1.1 ADDENDUM FORM

END OF ADDENDUM NUMBER NO. 3

Project title/Titre du projet 4TH FLOOR TENANT FIT-UP GREENSTONE BUILDING		Drawing title/Titre du dessin SECURITY WINDOW INTERCOM SINGLE LINE DIAGRAM	
Approved by/Approuvé par KO	PWGSC Project Manager/Administrateur de Projets TPSCG Brenda Embury	Scale/Echelle AS NOTED	
Designed by/Concept par JS	PWGSC, Architectural and Engineering Resources Manager/ Ressources Architectural et de Directeur d'Ingénierie, TPSCG	Date/Date 2017-06-28	
Drawn by/Dessiné par FD	Project No./No. du projet R.060383	Sheet/Feuille T2.1R3.1	Revision/ Revision

T2.1R3.1 1:125

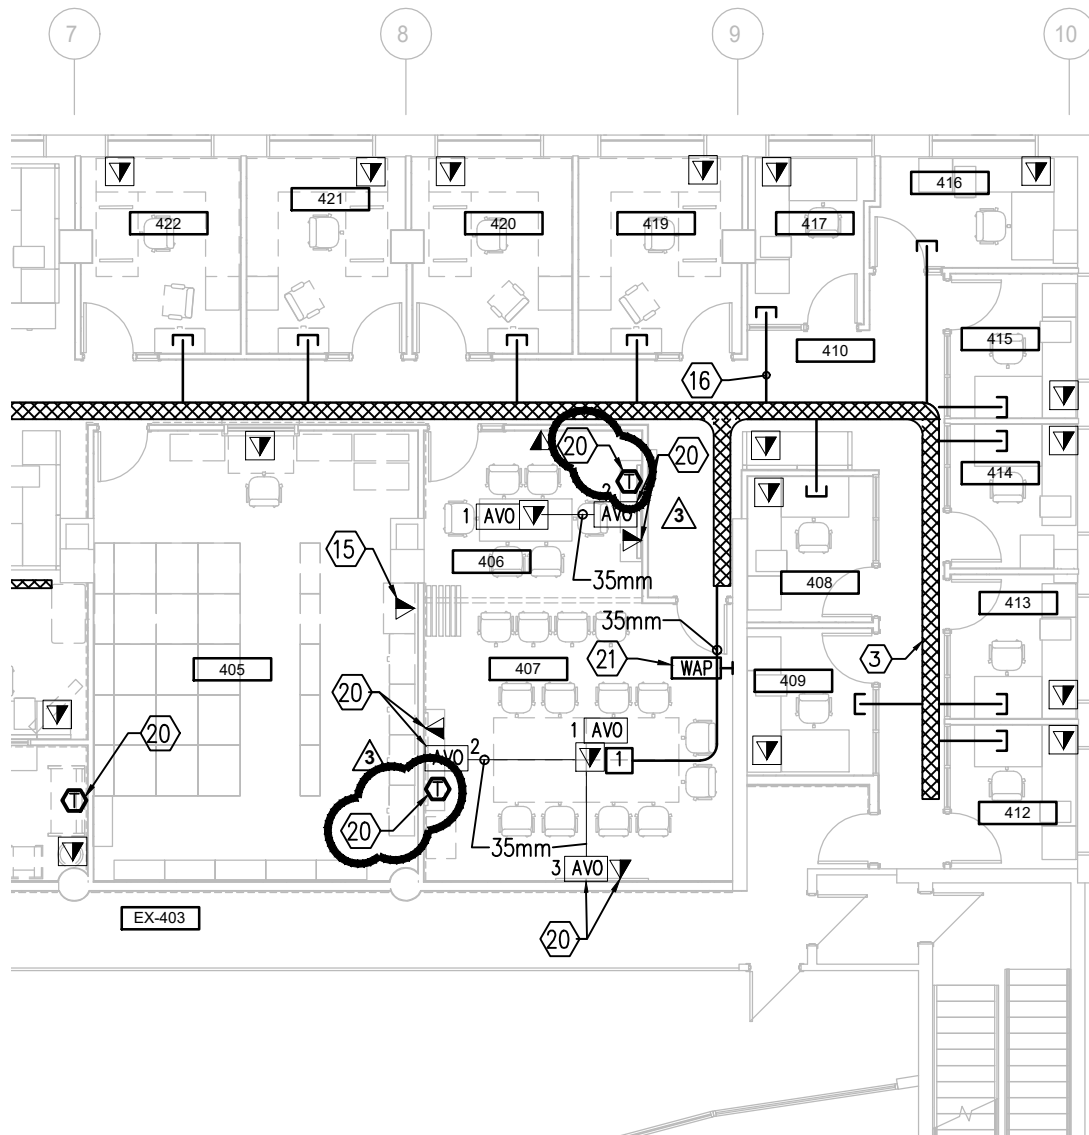
- .1 DRAWING T2.1 - New Telecommunications Layout
 - .1 **Add** TV outlet as indicated, refer to detail drawings T2.1R3.1 and T2.1R3.2 as attached. Install CATV distribution terminal block adjacent to access control panel.
